WATER PRODUCTION FACILITIES ELECTRICAL UPGRADES PROJECT

Solicitation Number: CO-00523

Job No.: 21-6007

ADDENDUM No. 3

SAN ANTONIO WATER SYSTEM
Water Production Facilities Electrical Upgrades
TREE PRESERVATION PLAN - TIPPECANOE

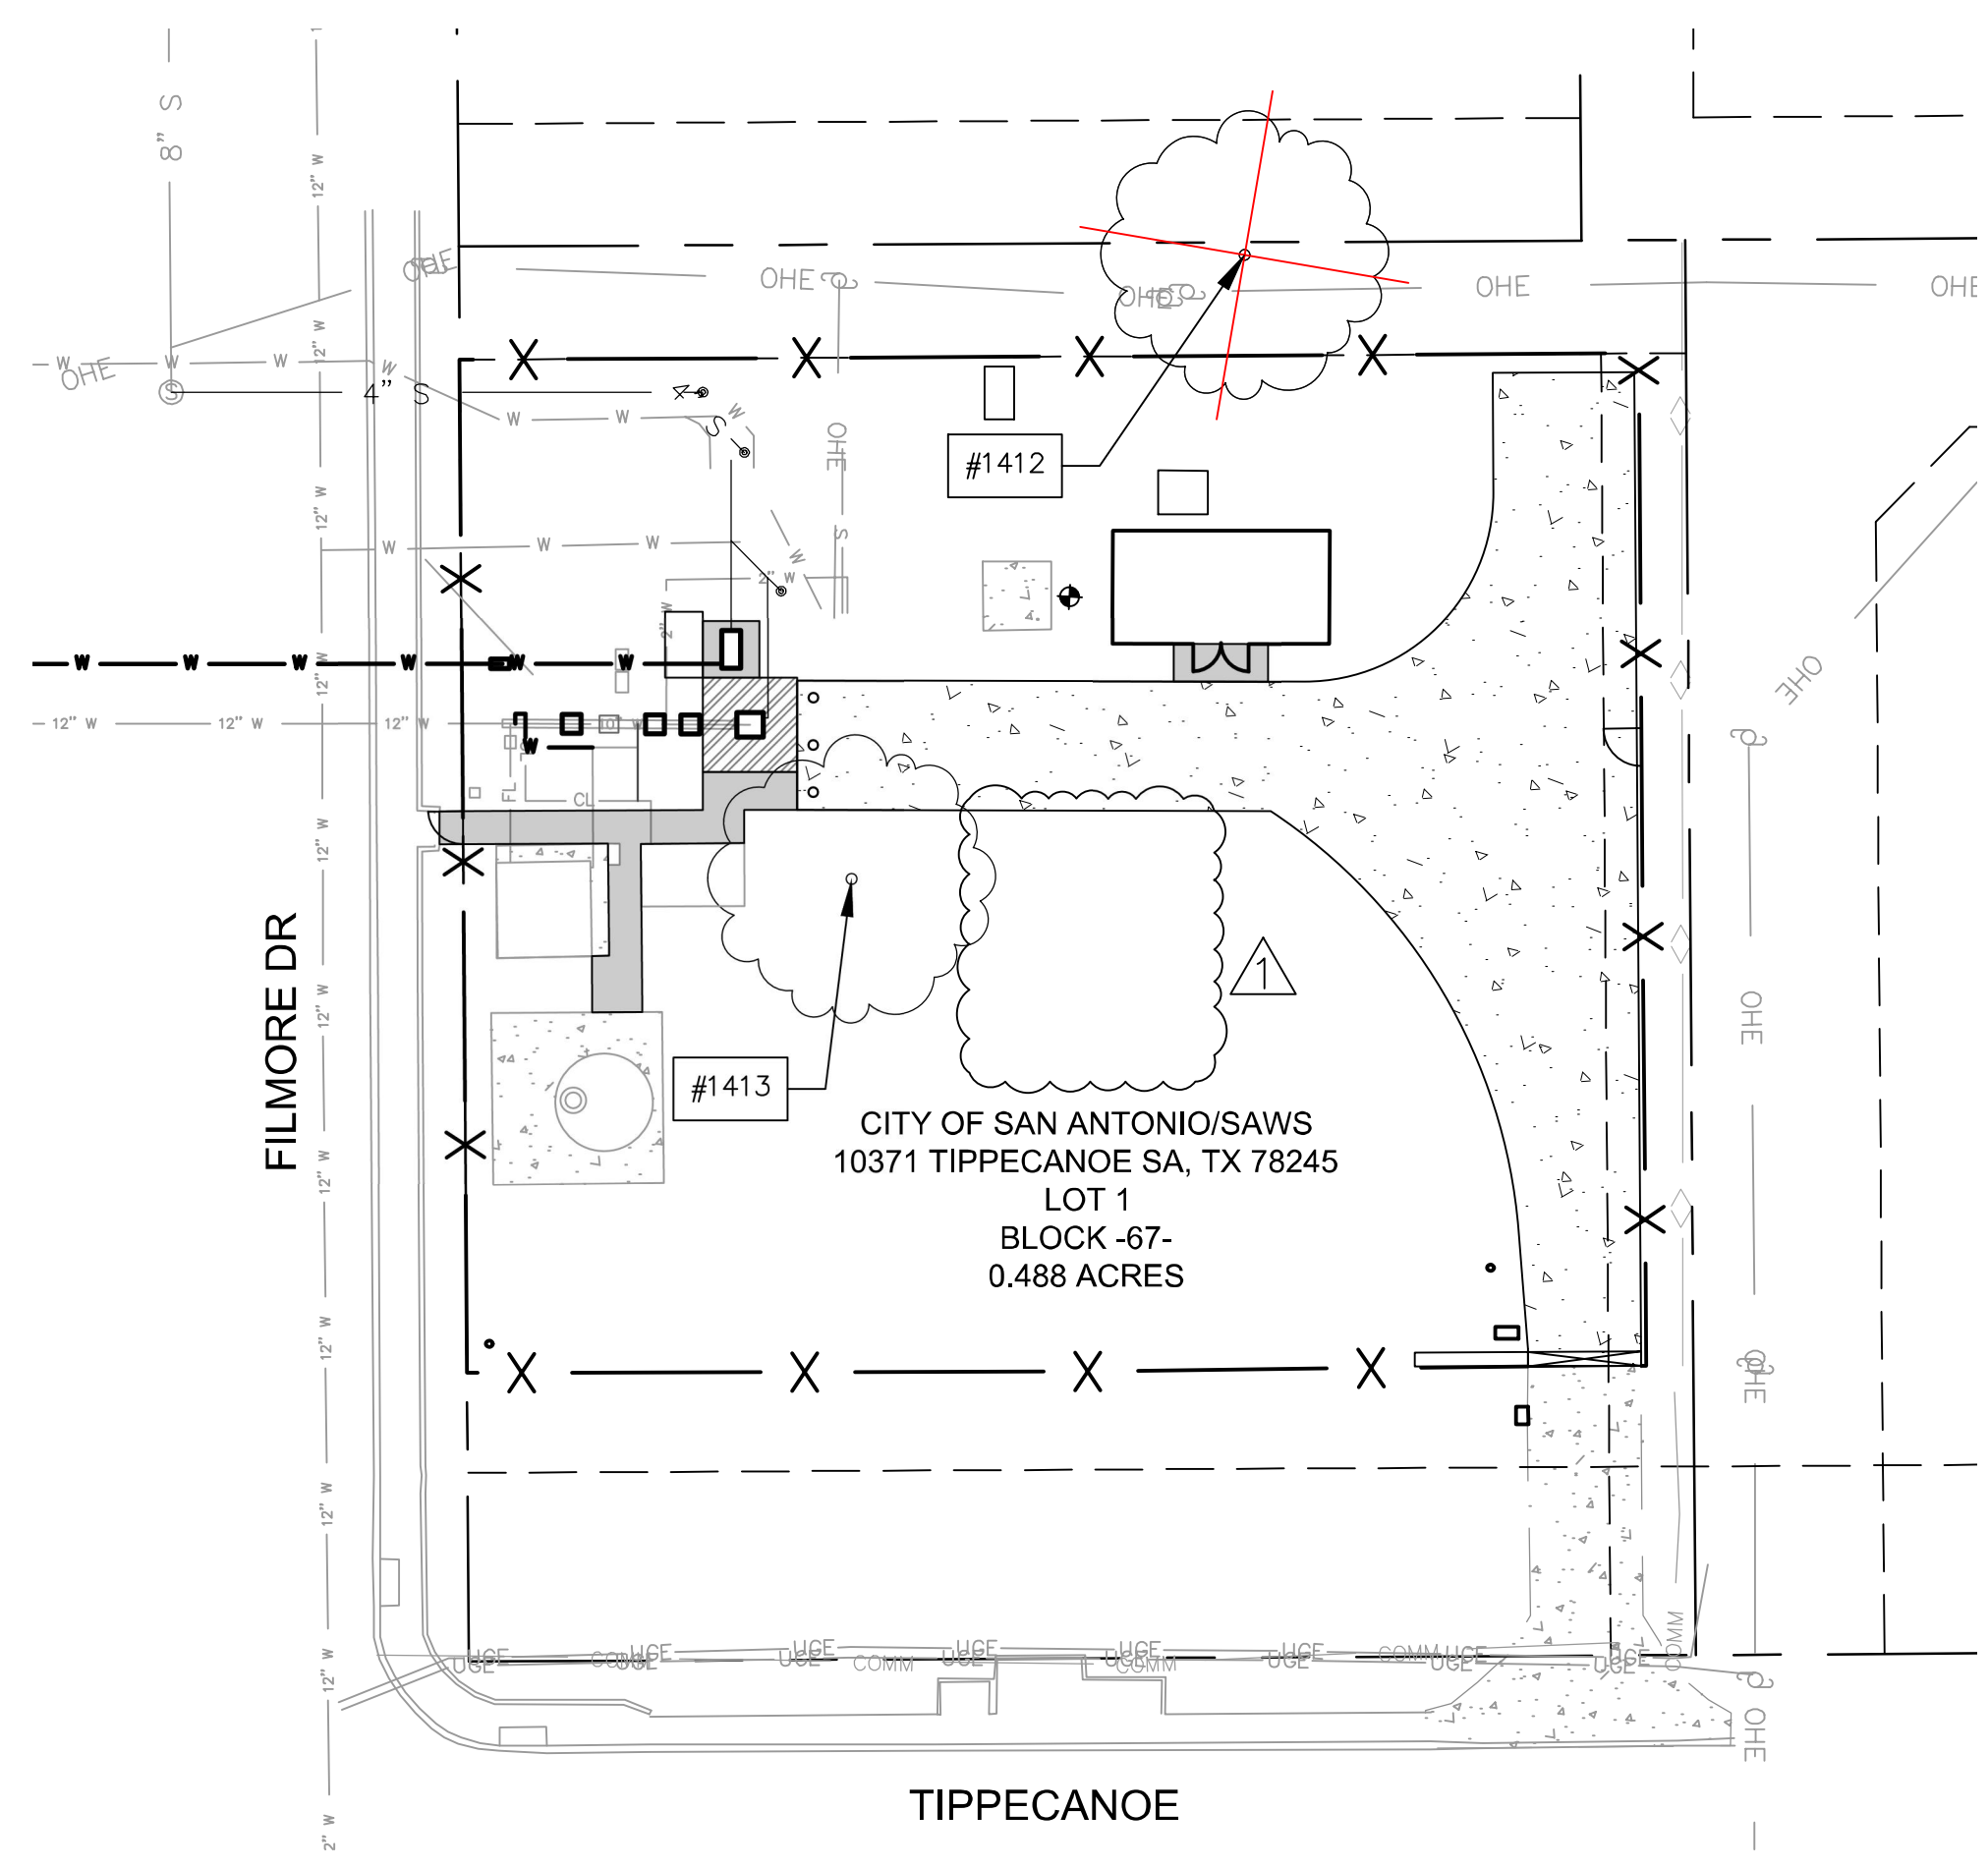
- 3. Drawing TP2 – Tree Preservation Plan – Tippecanoe
 - A. REMOVE and REPLACE this sheet in its entirety with the corresponding sheet attached to this addendum.

A PROPOSED ELECTRICAL ONE-LINE DIAGRAM
SCALE: N.T.S.

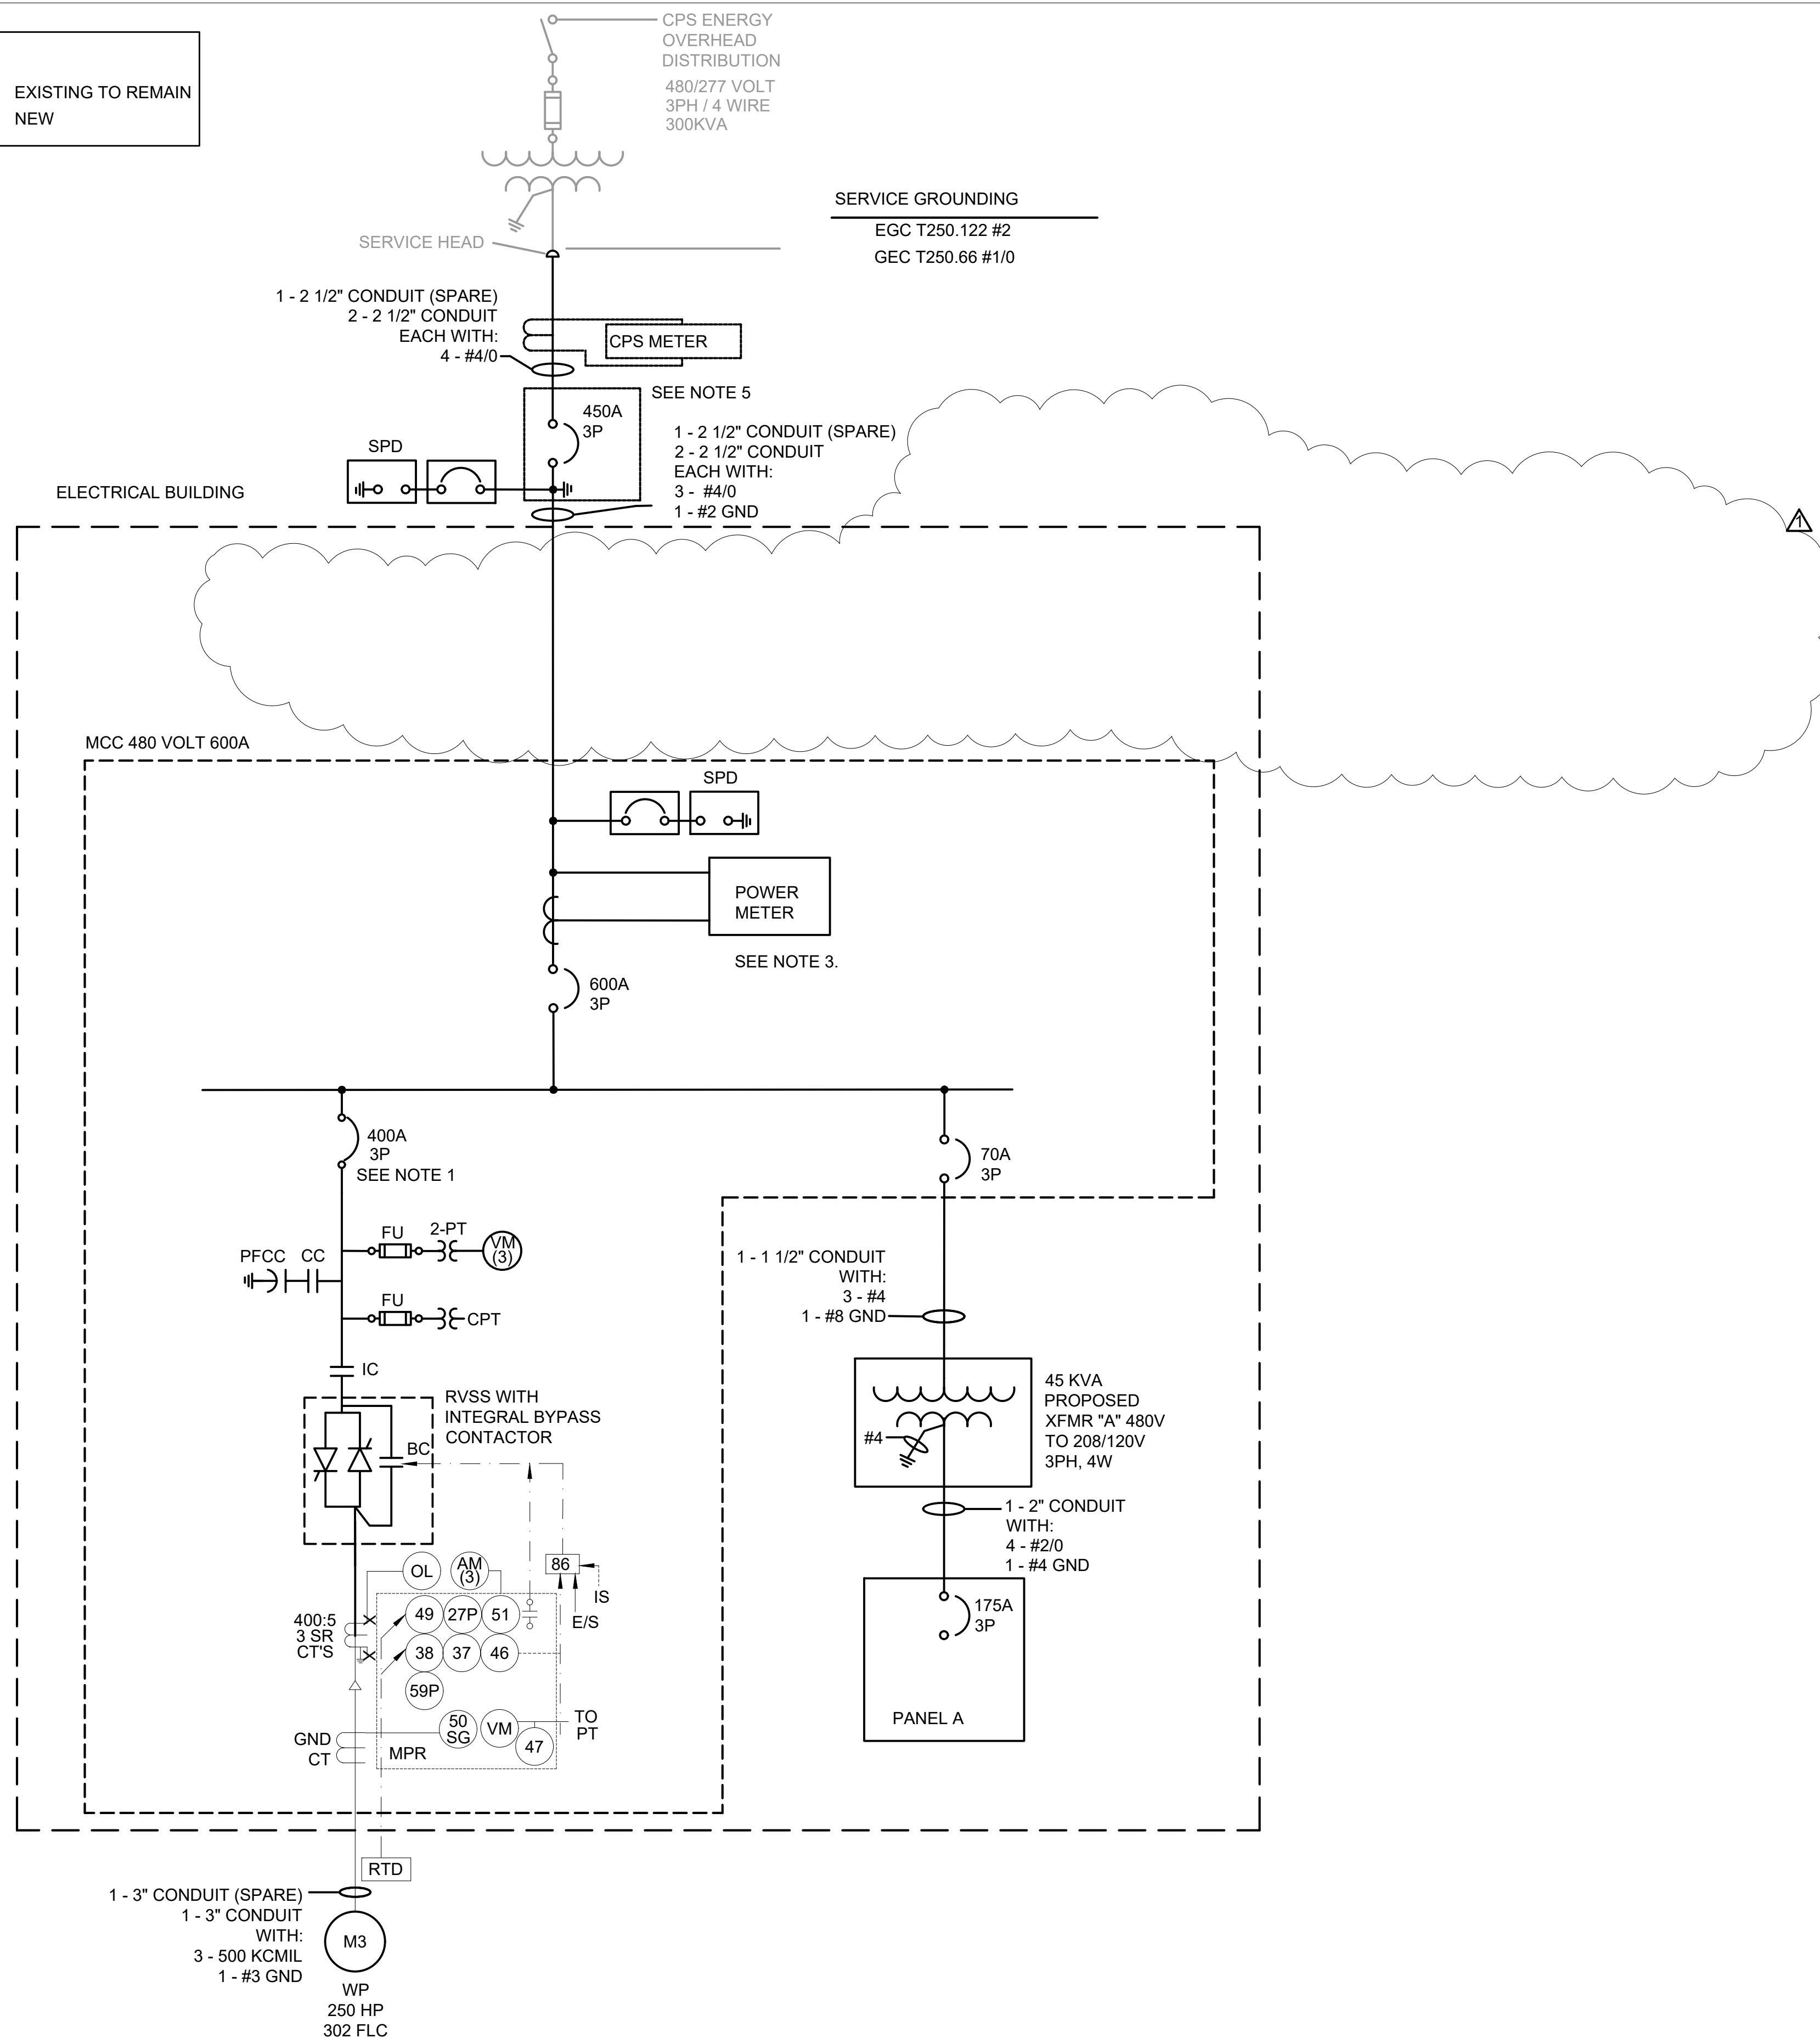
- 30. Other than a ground indication shown on 1-line diagram on E5, there are no other grounding system for the Generator detailed. Please clarify the grounding requirements.**

- 6. Drawing E5 – Proposed One-Line Diagram Tippecanoe
 - A. REMOVE and REPLACE this sheet in its entirety with the corresponding sheet attached to this addendum.

RESPONSE: The generator for the Tippecanoe site is removed in this addendum per modified plans sheets E5 & E6. Refer to "Changes to the Plans", items 6 & 7 in this addendum.
